SYSTEMATIC EVALUATION PROGRAM

Review of the Seismic Re-Evaluation Program  
of the Yankee Nuclear Power Station

September 1982

Figure 7. Exterior column.

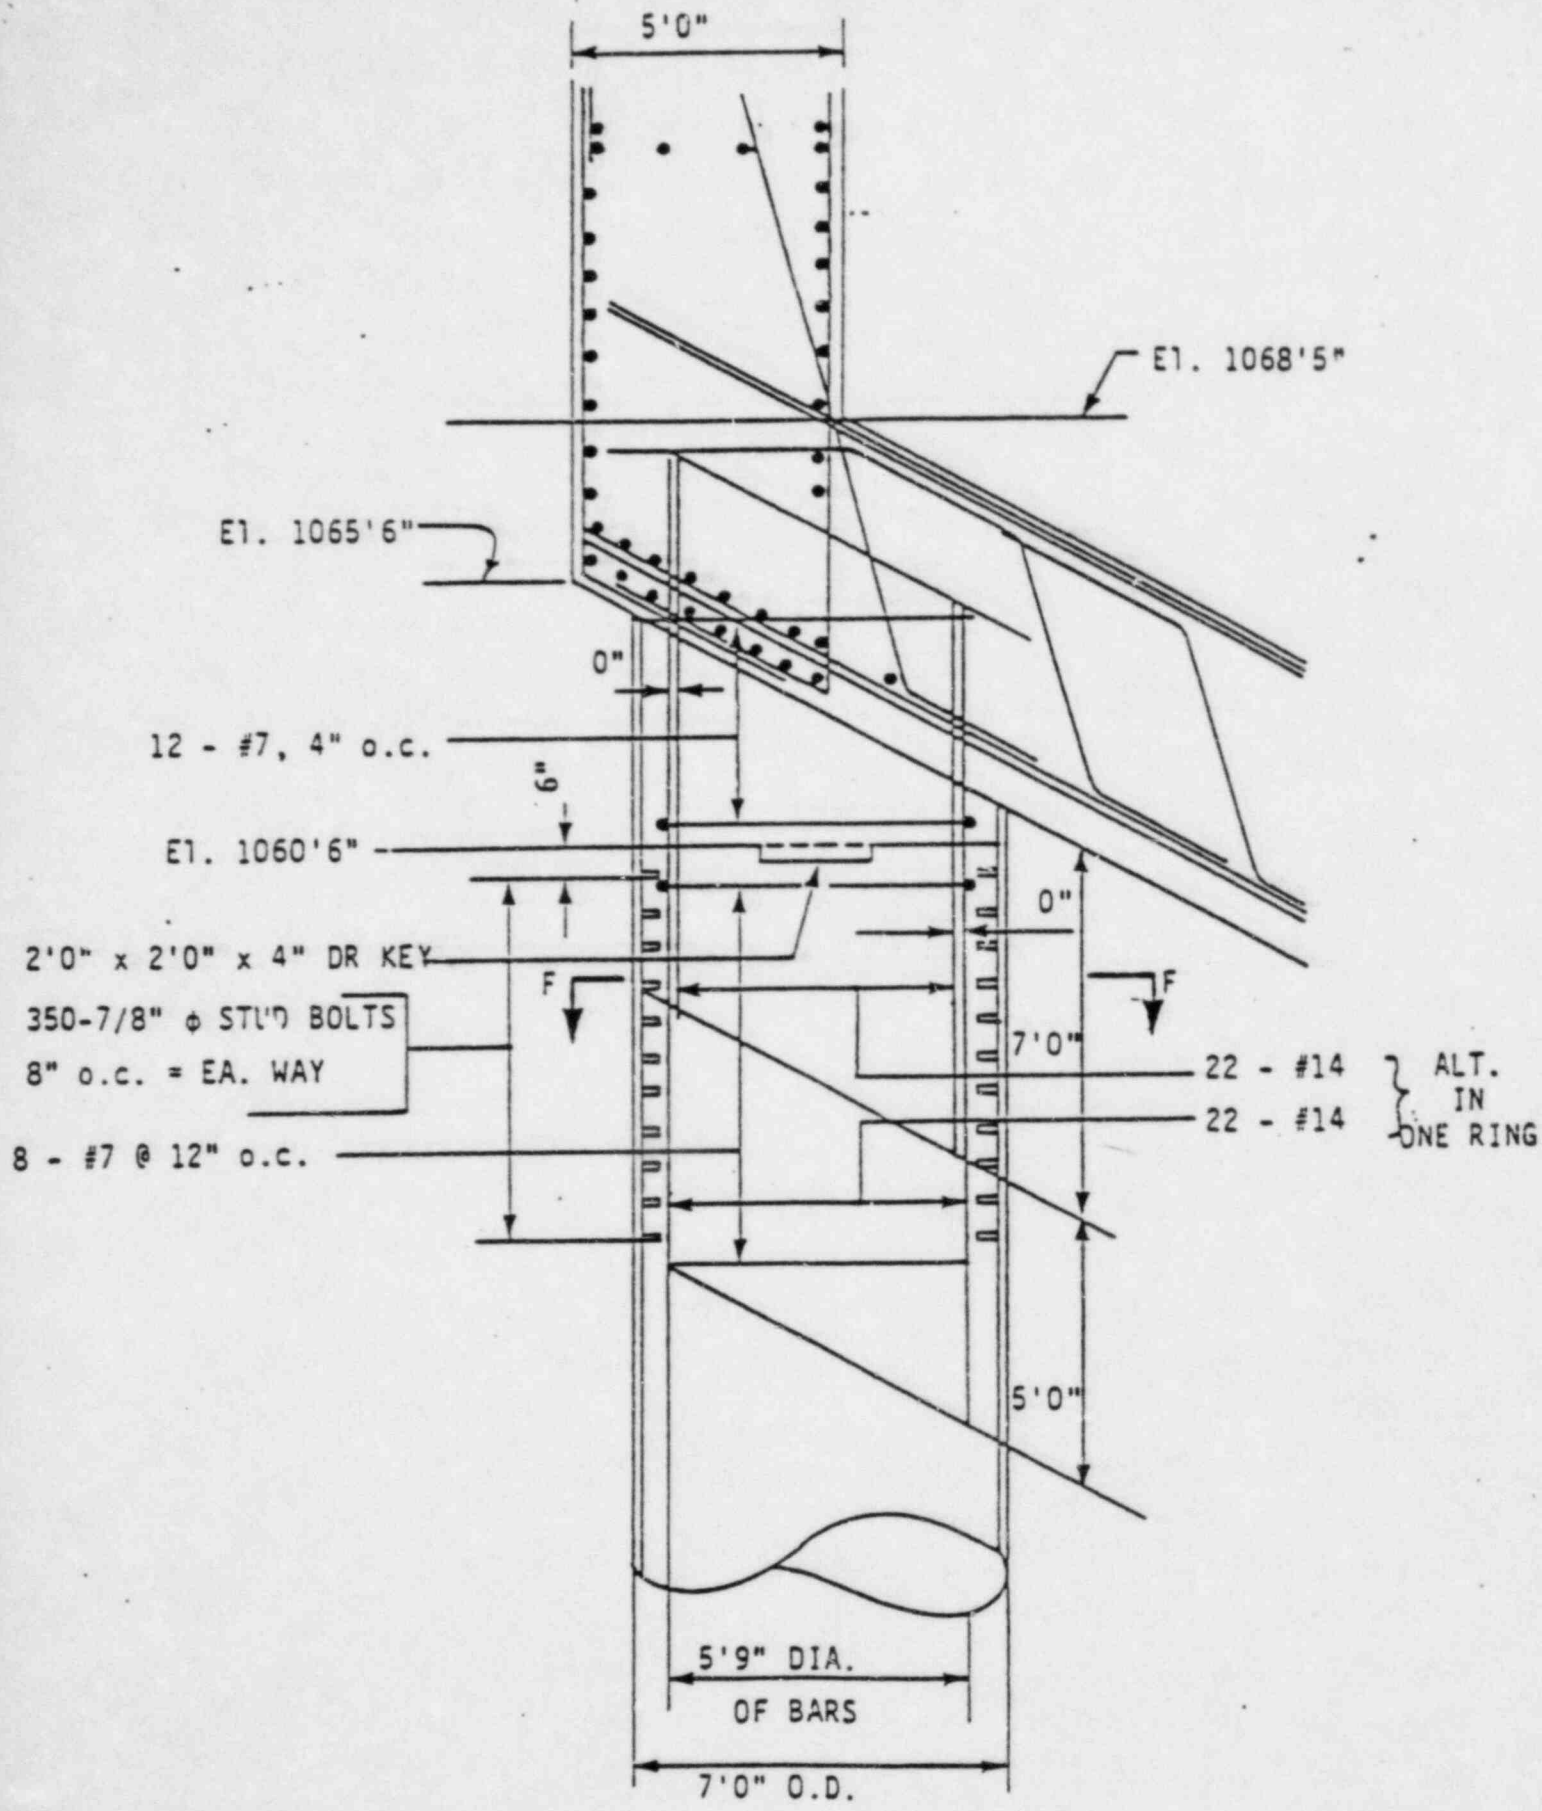
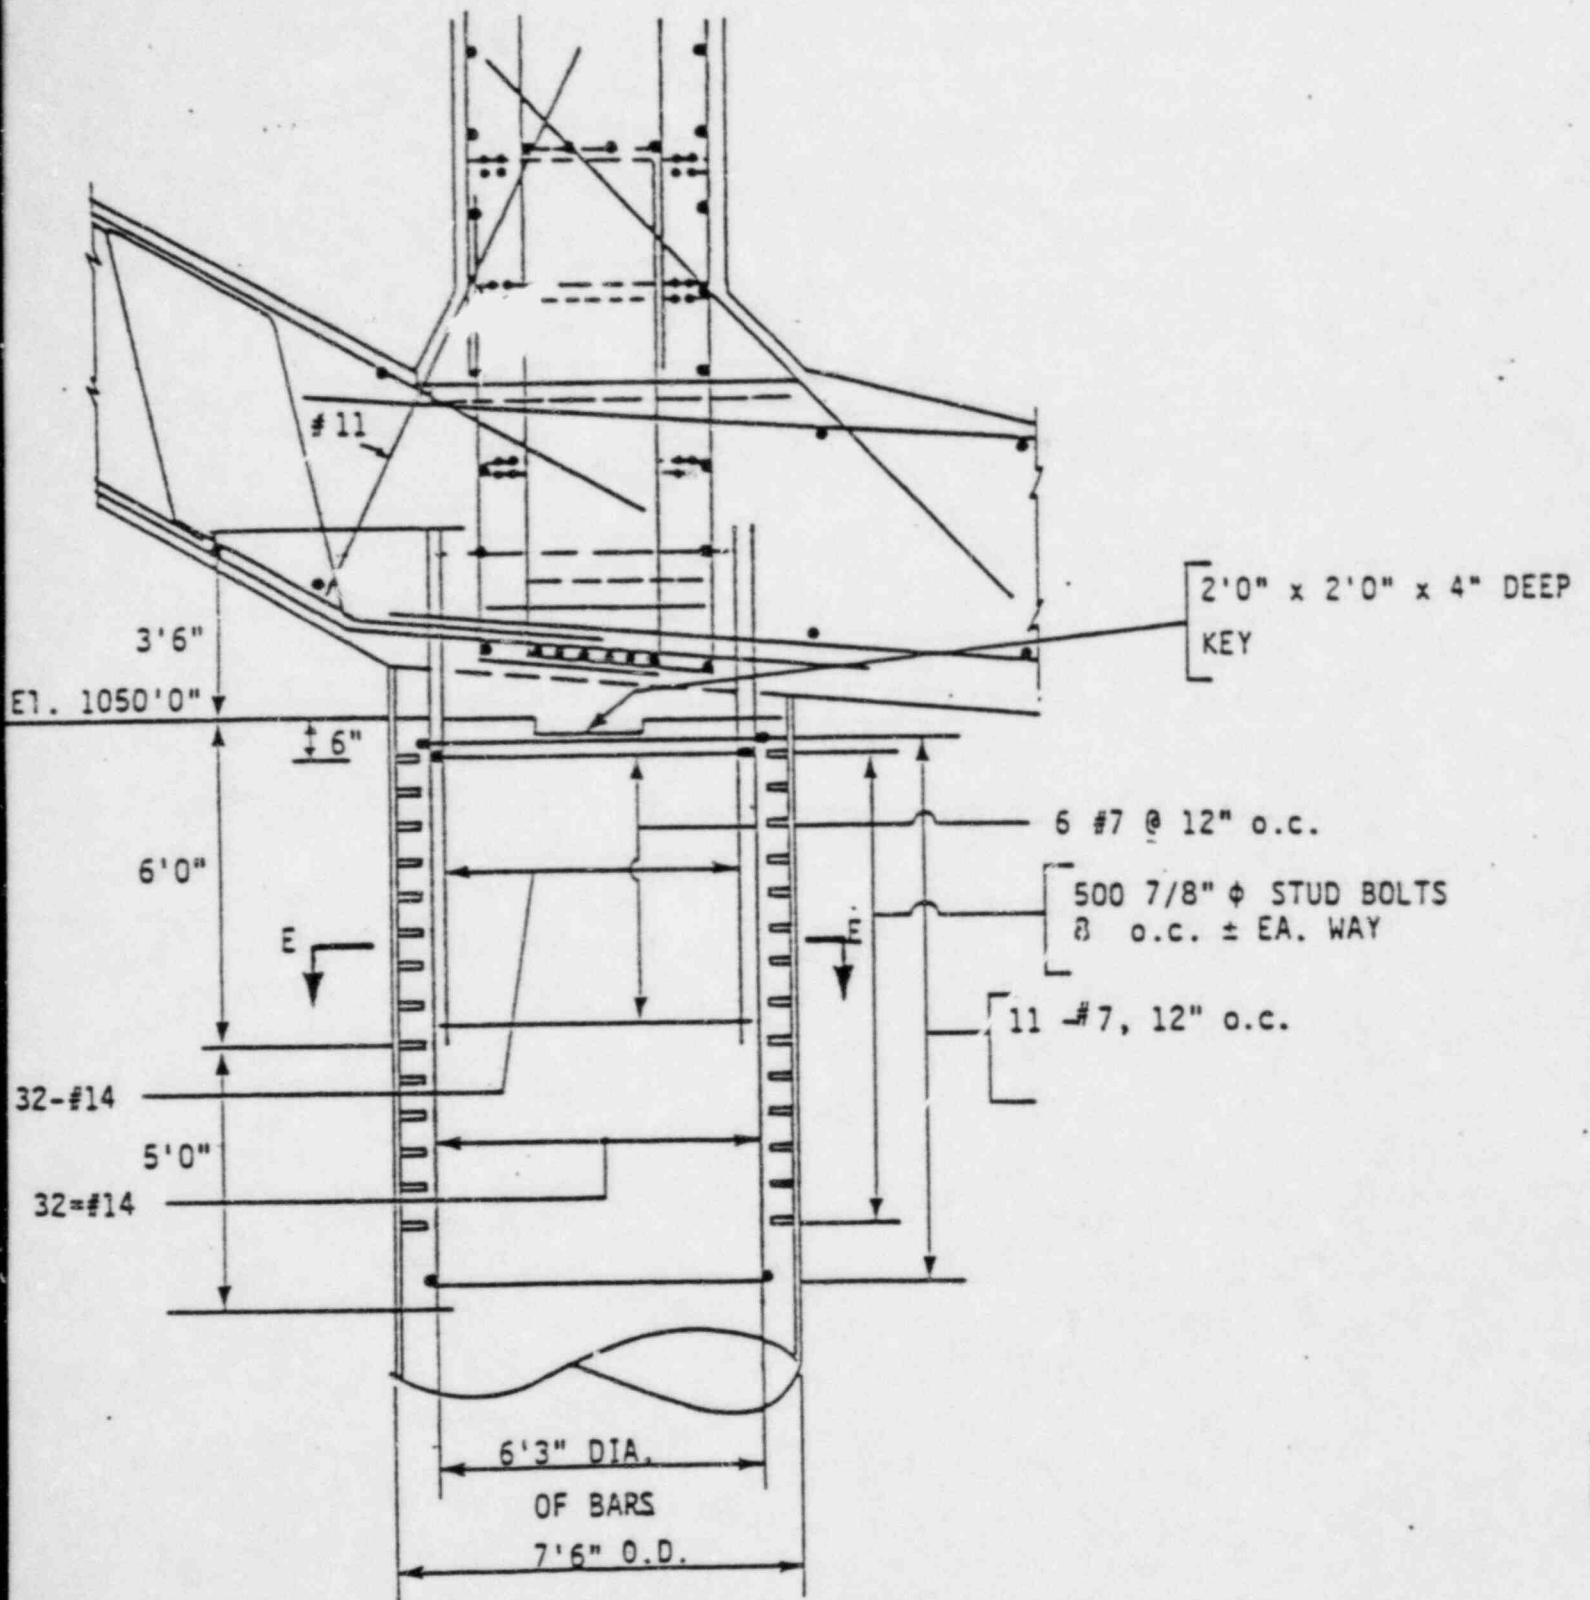
The adequacy of the connections between the concrete columns and the slab of RSS was evaluated by B. Bresler of Wiss, Janney, Elstner and Associates, Inc. His judgment is that there is no likelihood of a catastrophic collapse of the RSS due to failure of the supporting structure in a seismic event. However, the following issues should be resolved:

1. What is the steel grade and what is the appropriate stress-strain curve for the No. 14 bar dowels? Values of  $F_y = 40$  ksi and  $F_y = 50$  ksi have been used in different reports.

What effect does the steel yield strength and the shape of the stress-strain diagram have on the hysteretic behavior of the joint?

2. The size and type of studs should be identified and an analysis of load transfer from the steel shell through the studs and into the concrete and the dowel bars should be carried out. In particular, consequences of semi-ductile or brittle behavior on the local load transfer should be evaluated.
3. What is the maximum bond stress which can be reasonably expected in the connection? The value of 1000 psi used in the CYGNA analysis appears to be somewhat high. Justifications of the appropriate maximum bond stress value requires further documentation of the geometry of the surface deformations in the actual dowel bars. This information would then allow a better estimate of bond strength under monotonic loads.

In arriving at bond strength, credit has been taken for the effects of aging on the concrete compressive strength. However, concrete compressive strength at the top of a column is likely to be below average because of the normal amount of bleeding and dilution of paste.

Below the construction joint, circular ties are spaced at 12 in., and the dowel bars in the interior columns are too closely spaced. Local cracking around the stud bolts may further reduce the ultimate bond strength.

4. Anchorage length of 42 inches is assumed in developing a bilinear force-displacement curve for the No. 14 bar dowel. This anchorage length is based on the arrangement of steel in the interior columns. Some bars in the exterior columns have an embedment length of only about 24 in. The following questions must be resolved: Can yield strength of No. 14 bar be developed in a 24-in. anchorage length and with reduced bond stress, and what effect, if any, does this condition have on the overall behavior of the structure?

Figure 20. Suggested fixes for the Primary Auxiliary Building. (Sheet 1 of 2.)

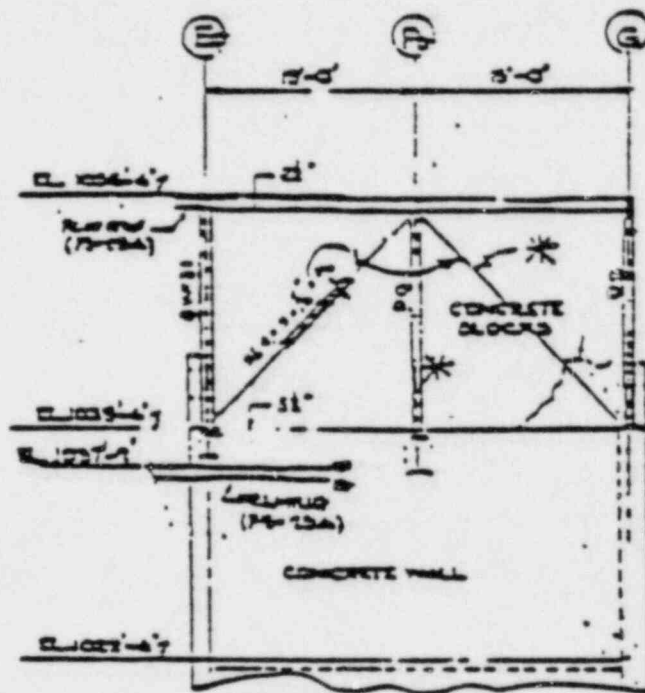
The predicted stresses in general are low. However, at some connections of steel beams to concrete walls, overstresses can occur.

Minor fixes are required to upgrade the primary auxiliary building in order to meet the Yankee composite spectra. The upgraded structure is expected to meet the NRC spectra. Figure 20 shows some of the fixes suggested by CYGNA for the primary auxiliary building.

\*THESE MEMBERS, INCLUDING  
END CONNECTIONS, ARE  
REQUIRED "FIX" BASED  
ON THE NRC [ ] AND  
THE YCS.
